Proposed TDECQ Change in Clause 138.8.5*

Frank Chang, Inphi; Hai-Feng Liu, Intel

IEEE P802.3cd Interim Meeting, Charlotte, NC, September 2017

One serious problem for directly modulated lasers: Amplitude-dependent skews with PAM4 eyes

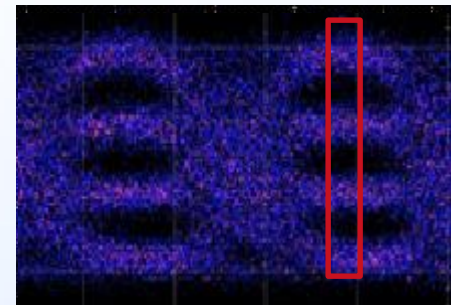
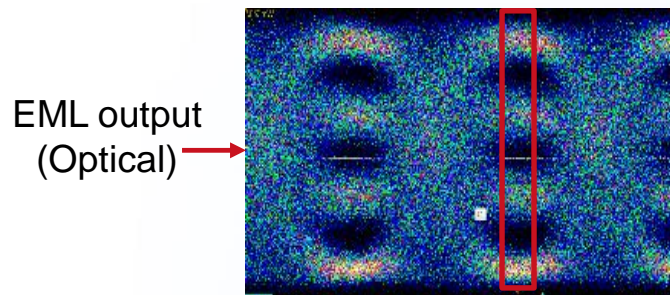
- Laser characteristics with direct modulation cause seriously skewed waveform.
 - Such non-linearity compensation can be readily implemented in PAM4 RX DSP and/or driver devices.
 - However, this is not defined in current TDECQ methodology possibly resulting in unrealistic & larger TDECQ values.

VCSEL output (Optical)

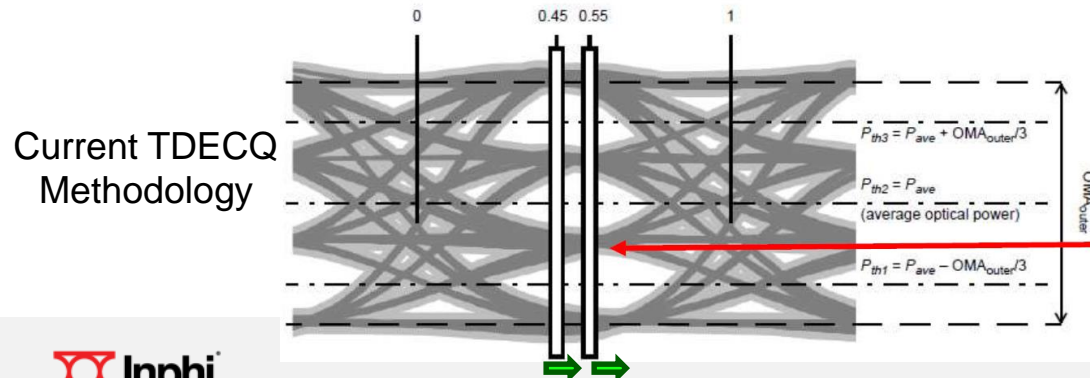
Note:
 The proposal to allow the overall sampling timing to move may not align skews independently between 3 PAM4 eyes

VCSEL Transmitter (P802.3cd D2.1 5 T-spaced at 11.2GHz)

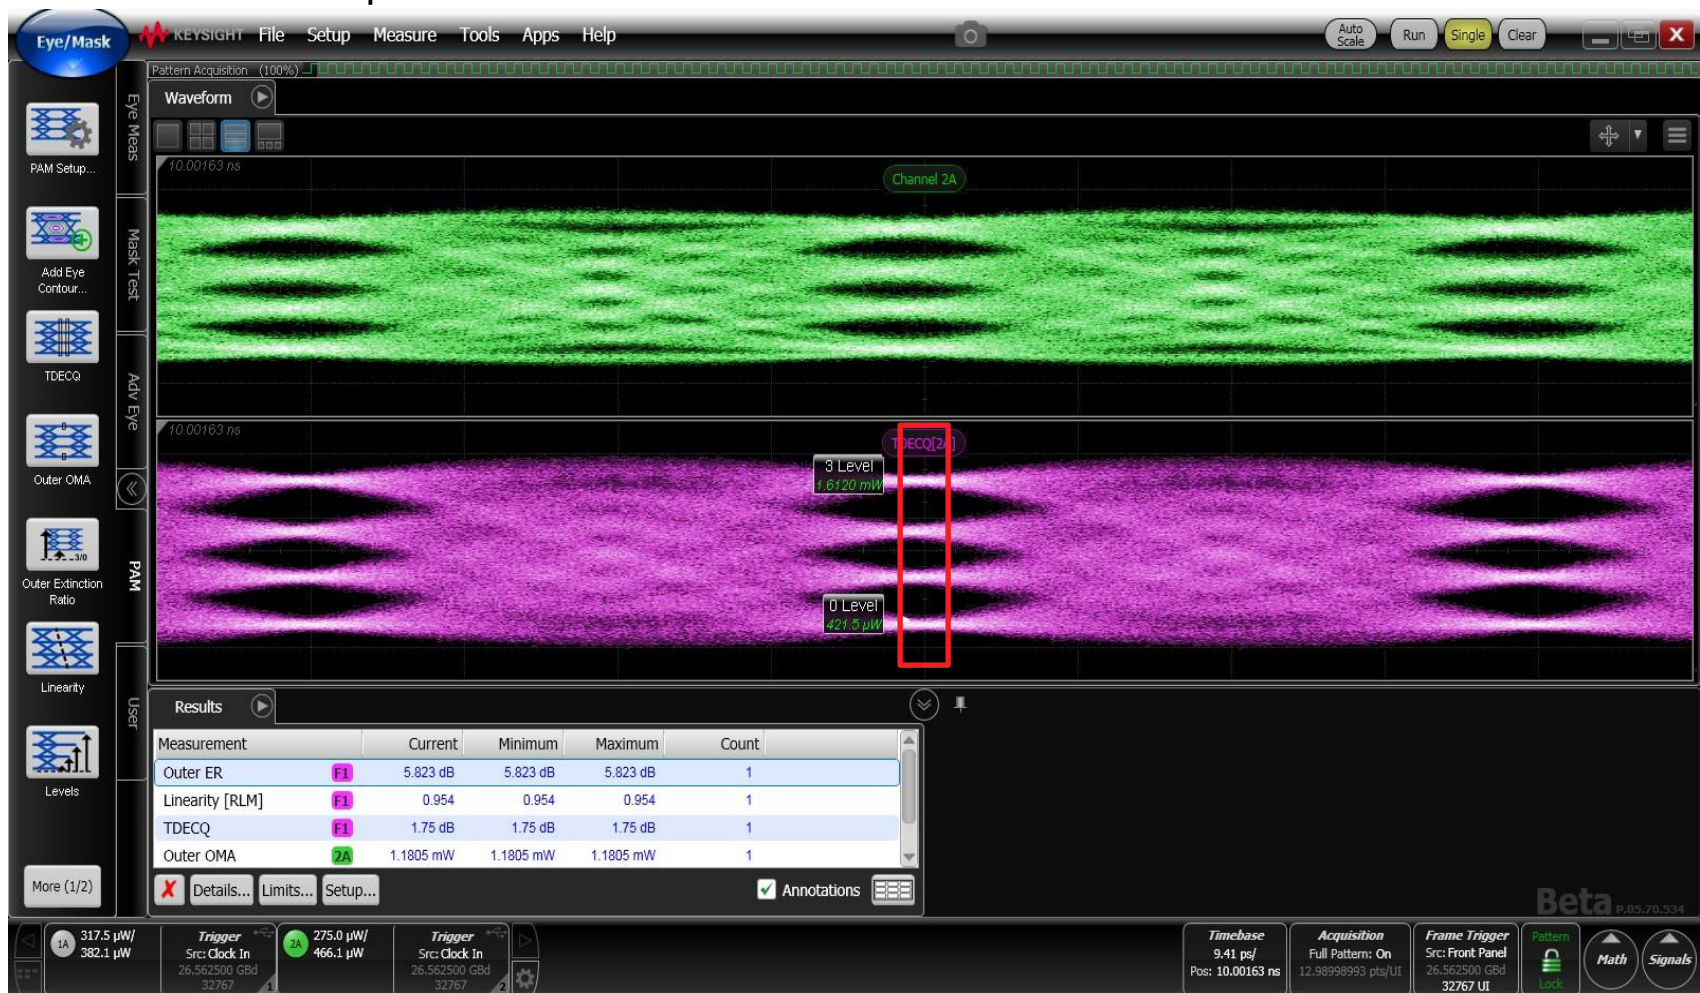
- Much larger TDECQ variation (~1-1.5dB) for 5 taps, versus ≤ 0.5 dB for 7-9 taps.
- PAM4 DSP ASICs have implemented 9 or more T-spaced taps
- The modulation BW of directly modulated VCSELs normally limits to ~18GHz at optimum biasing current, and drops dramatically near threshold currents, resulting in seriously skewed PAM4 eyes (amplitude dependent).
- PAM4 chip implementation may readily incorporate non-linear compensation for vertical eye skews.

- Current TDECQ specs cause unnecessary yield loss of VCSEL-based transmitters, so is less practical.
- We propose to change Clause 138.8.5 for:
 - Reference equalizer from “5 tap, T spaced” to “7-9 tap, T-spaced”
 - Note tests with 7-9 tap also show much better TDECQ stability than 5 tap.
 - 4th-order Bessel-Thomson filter response from a bandwidth of “11.2GHz” to either “12.6GHz” or “13.28GHz”.
 - 13.28GHz (Nyquist) is more consistent with the filter definition for all other SMF PMDs.
- Amplitude-dependent skews in PAM4 eye openings call for the need for non-linear compensation.
 - This could apply to directly modulated VCSELs and DFBs.
 - The proposal to allow overall sampling timing window to move (but not independently between the 3 eyes) may help, but whether it will fully resolve the issue or not remain to be seen.
